E8361A-13 <u>S E R V I C E N O T E</u>

E8361A PNA Microwave Network Analyzers

An enhancement added to absorb vibration when opening the swing deck during hardware repair.

Figure 1

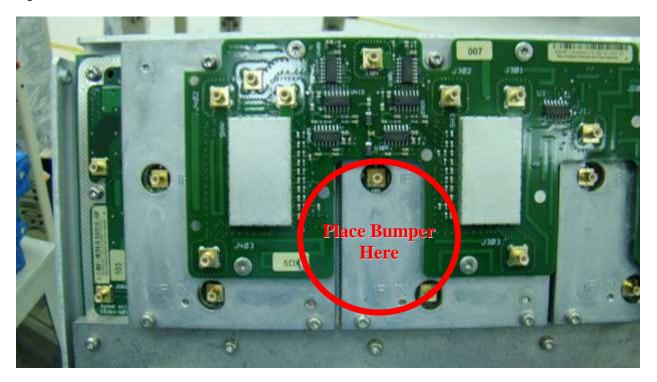
A rubber bumper – E8361-40001 is available to improve the serviceability of the instrument. This will also ensure the swing deck well separated from other nearby assembly.

- 1. Go to http://na.tm.agilent.com/pna/documents.html.
- 2. Click on the appropriate Service Guide.
- 3. When the PDF of the Service Guide is displayed, look at the bookmarks in the left column. Expand the Contents section by clicking on the plus sign next to its bookmark.
- 4. Scroll through the Contents section bookmarks to locate "Repair & Replacement Procedures."
- 5. Click on the title/hyperlink for the section "Receiver Deck."
- 6. Follow the instructions in the subsection "Raising and Lowering the Receiver Deck."
- 7. Once the Receiver Deck has been lower, installed the Bumper as shown in Figure 2.
